Memorandum

RE: **P.Z. 05-2021 Chesterfield Airport Service (Enterprise):** A request for a zoning change from a “M3” Planned Industrial District and “PI” Planned Industrial District to a new “PI” Planned Industrial District for a tract of land totaling 1.005 acres located north of the intersection of Chesterfield Airport Road and Cepi Drive (17V520082, 17V520071).

Planning Commission Staff Report

Description: **P.Z. 05-2021 Chesterfield Airport Service (17909 & 17947 Chesterfield Airport Road):** A request for a zoning change from “M3” Planned Industrial District and “PI” Planned Industrial District to a new “PI” Planned Industrial District for a tract of land totaling 1.005 acres located north of the intersection of Chesterfield Airport Road and Cepi Drive (17V520082, 17V520071).

Figure 3: Preliminary Development Plan

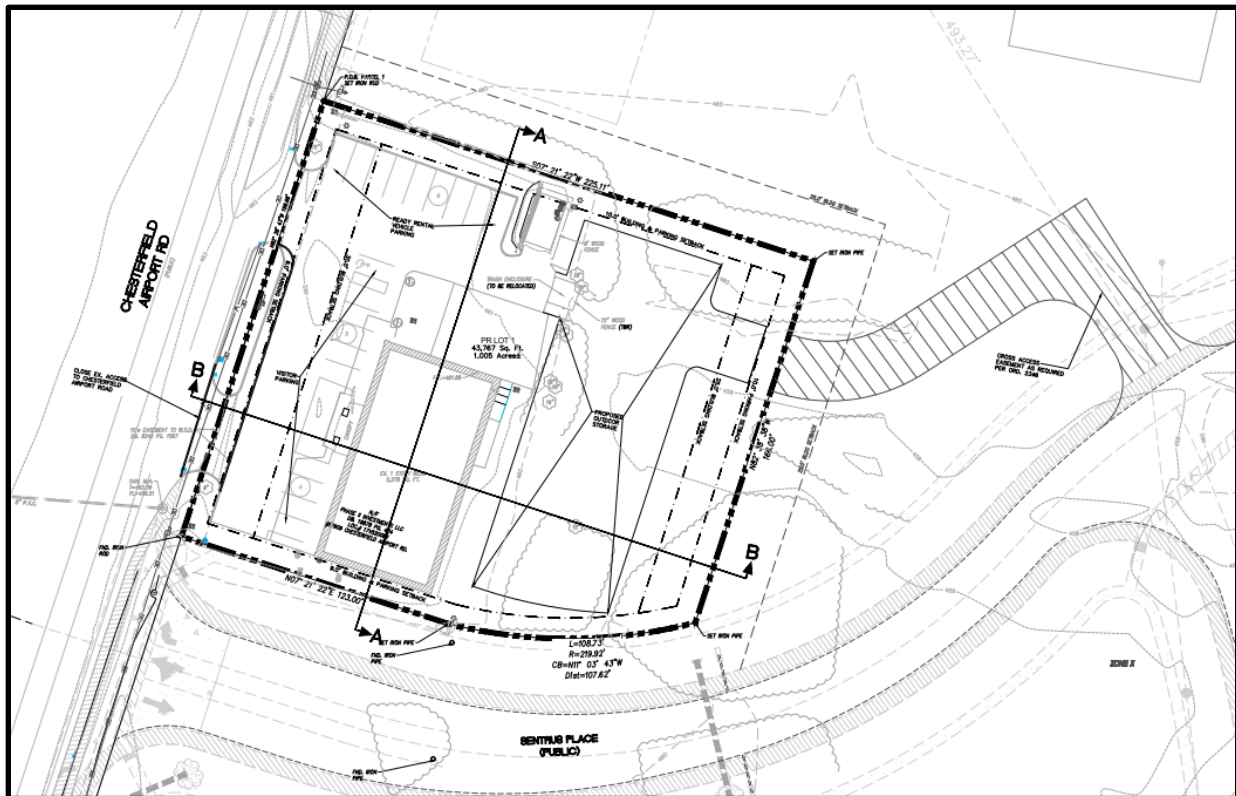
Issue #2—Access

Issue: Planning Commission expressed concern that the proposed site did not have cross access to the proposed road Sentrus Place. Once the neighboring development of Sentrus Drive is developed, a roadway will be constructed along the eastern boundary of the subject property. Access to this future roadway should be accommodated in the Preliminary Development Plan.

Applicant Response: The applicant has revised the Preliminary Development Plan to ensure access to the future roadway. A cross access easement is now shown on the plan that aligns with the Sentrus Place approved Concept Plan.

Staff has included language detailing the access requirement in the Draft Attachment “A” language for Planning Commission’s consideration.

SHEET TITLE:
PRELIMINARY
DEVELOPMENT PLAN
SHEET NO.:
C1.0

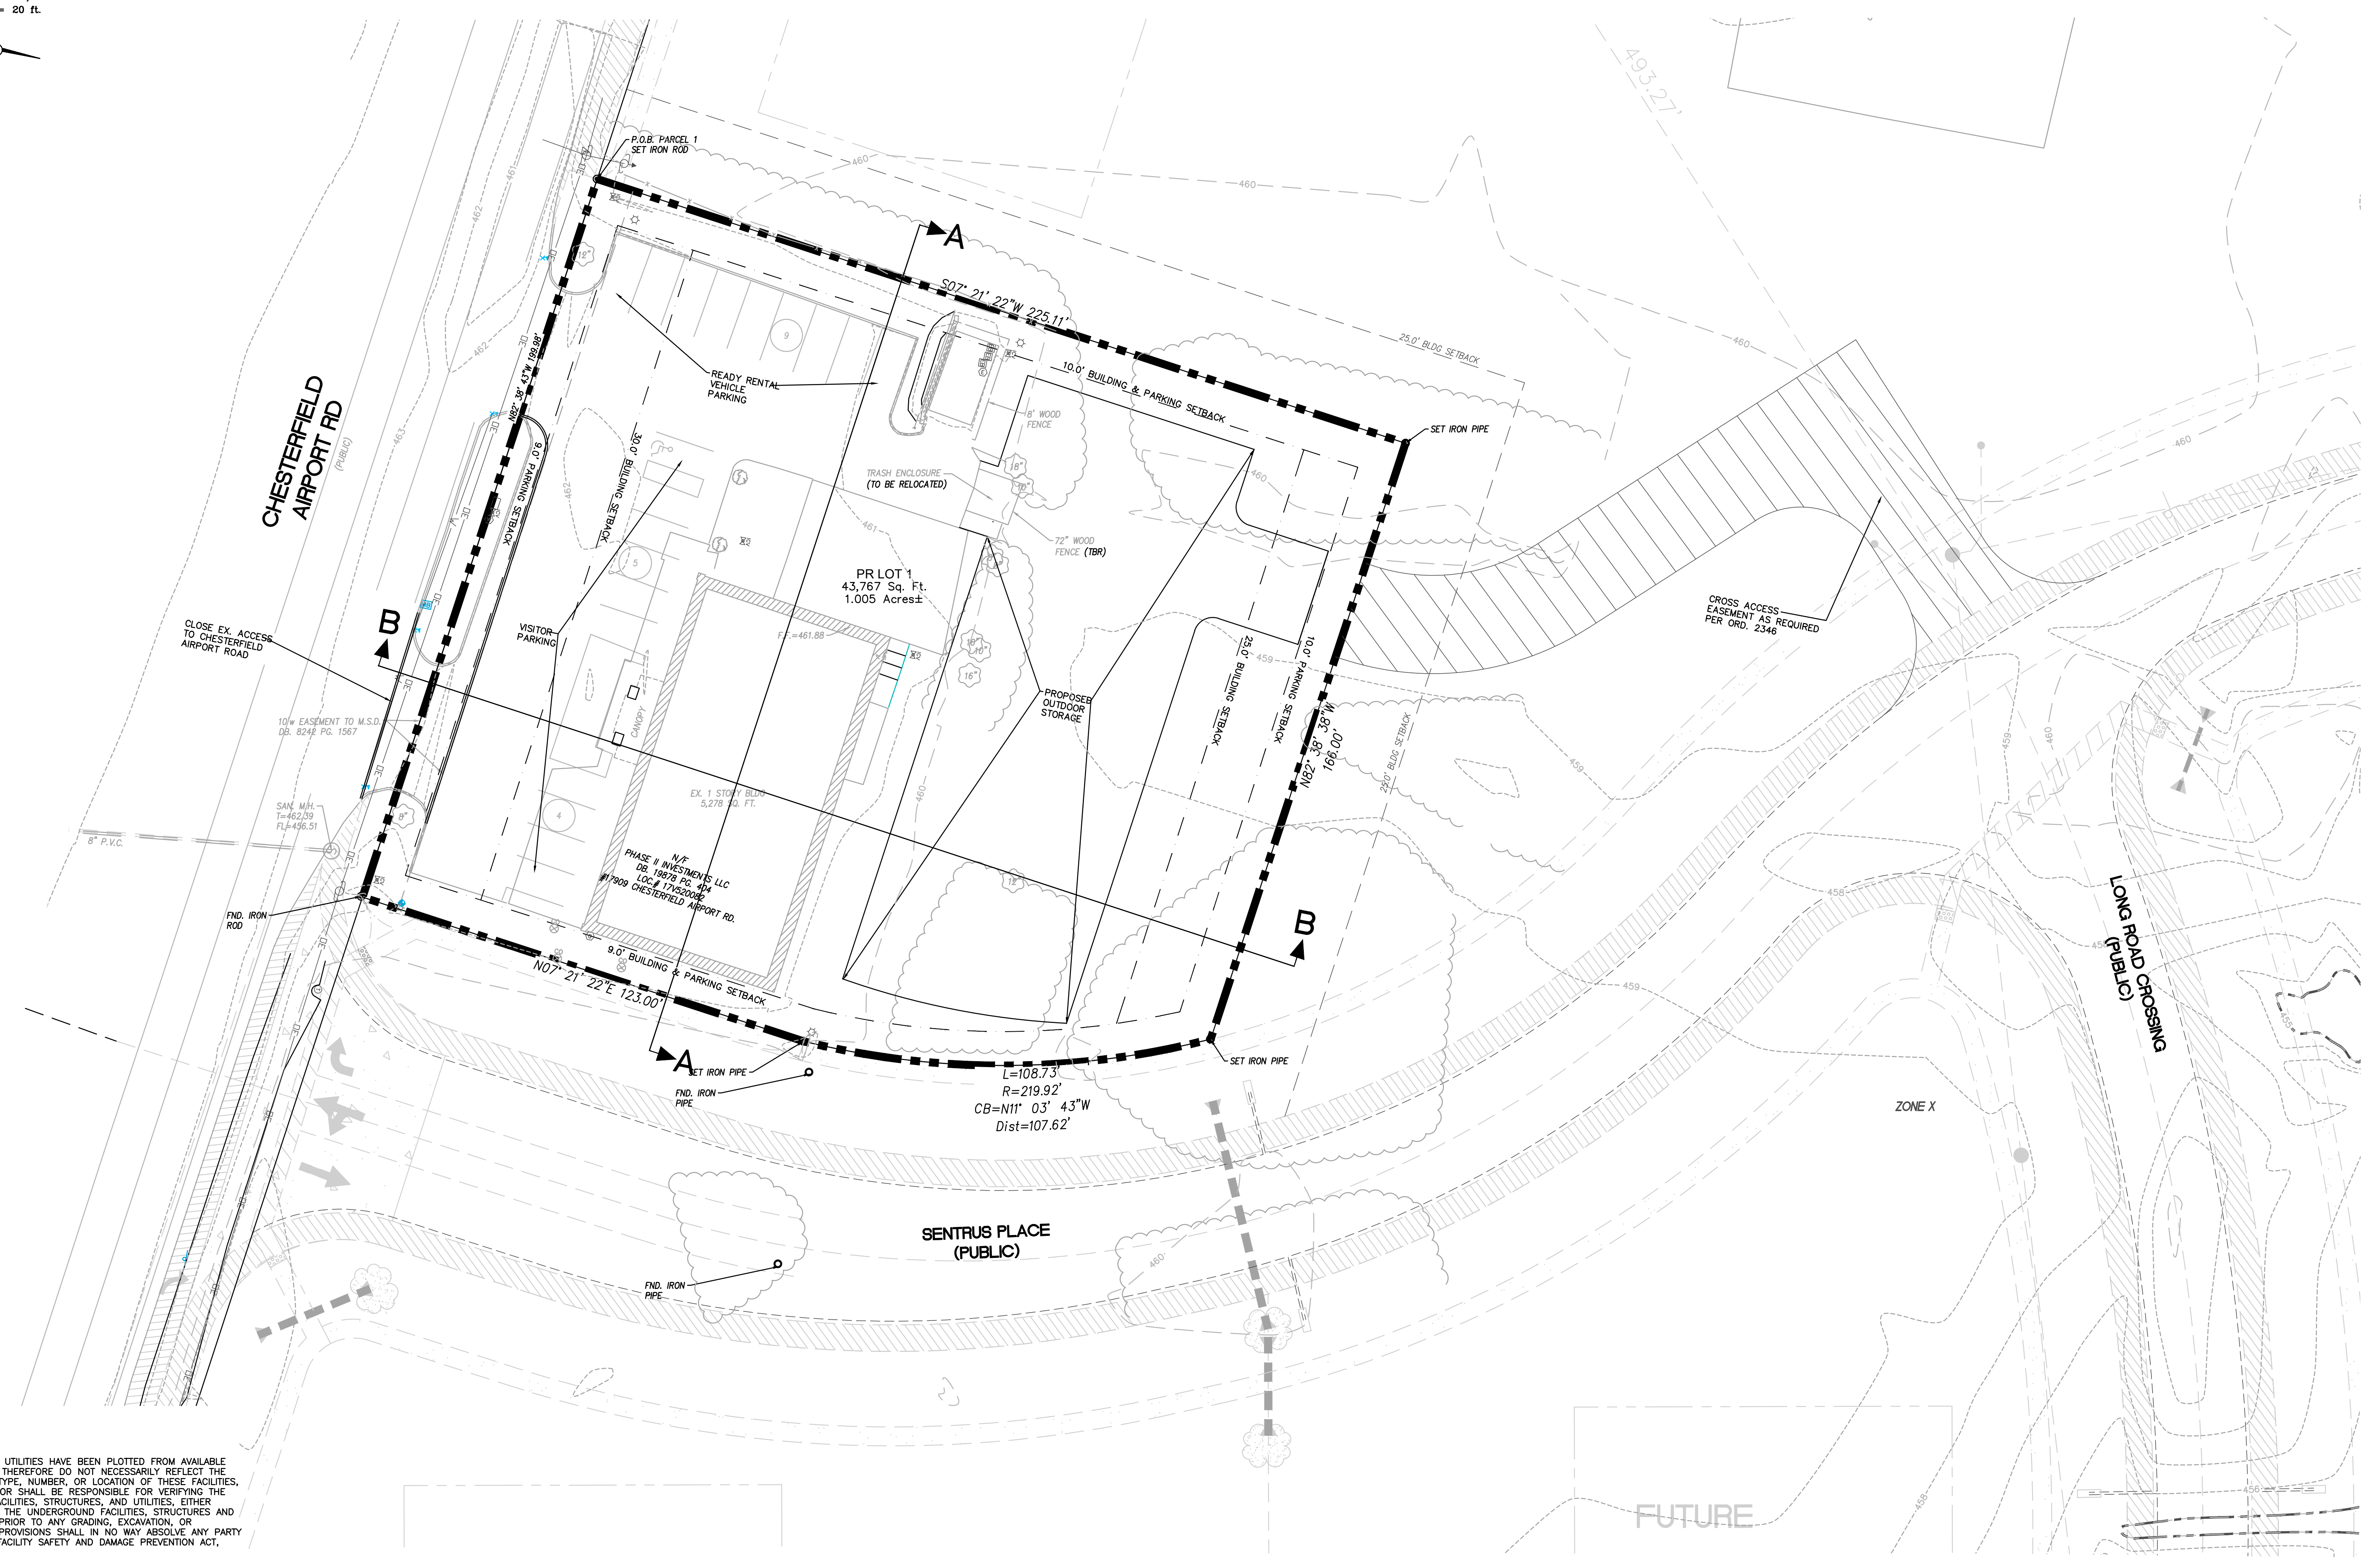
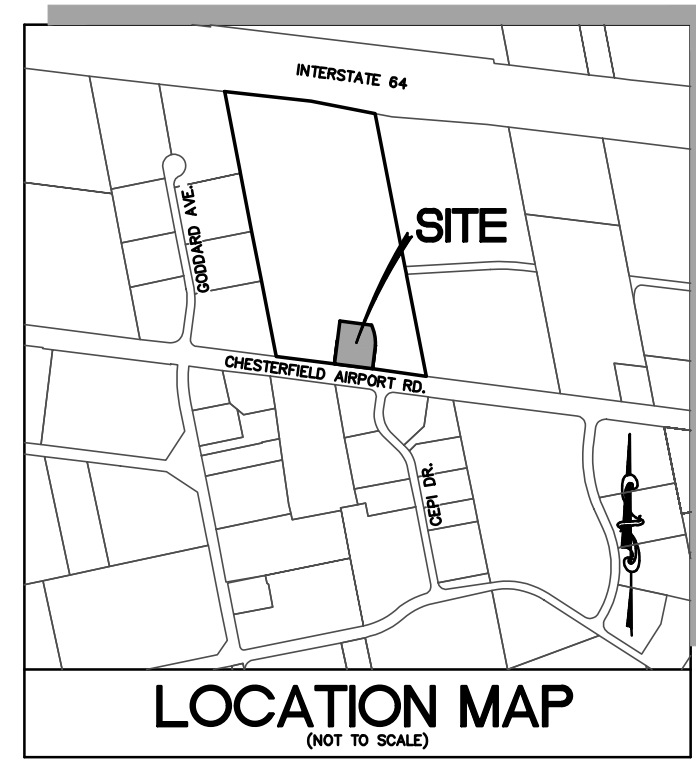
1. **Issue**—Consider revising the Preliminary Site Plan to accommodate future access to Sentrus Place.
Applicant Response: Future access to Sentrus Place has been added to Preliminary Development Plan.
